1997 - 1999 Corvette: Service Bulletin: Accessory Drive Squeak (Replace Idler Pulley)

Number: 99-06-01-007

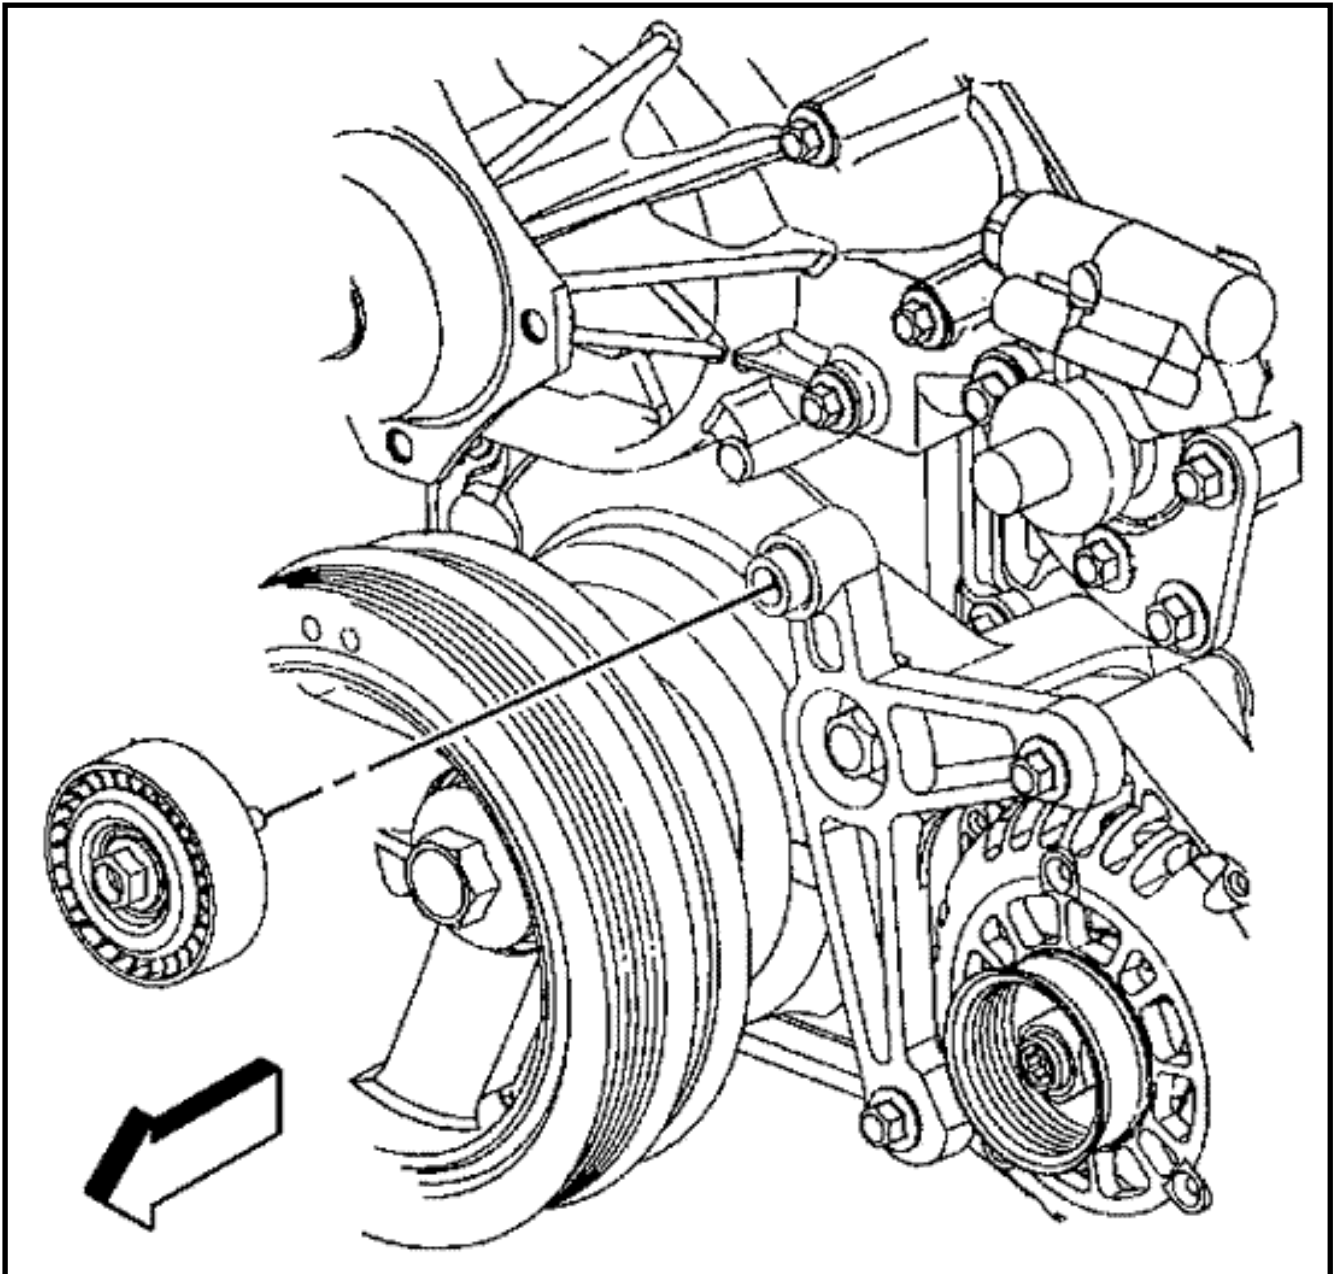
The idler pulley dust shield may distort during assembly due to torquing of the mounting bolt. This distortion may cause the idler pulley dust shield to contact the bearing race and the pulley resulting in the squeak noise.

A new idler pulley assembly is available with a thicker dust shield to prevent the distortion of the dust shield. The previous dust shield thickness is 0.61 mm. The new dust shield thickness is 1.37 mm.

- **Do not over-torque the mounting bolt or the condition may reoccur.**

Torque the idler pulley bolt to 50 N·m (37 lb ft).
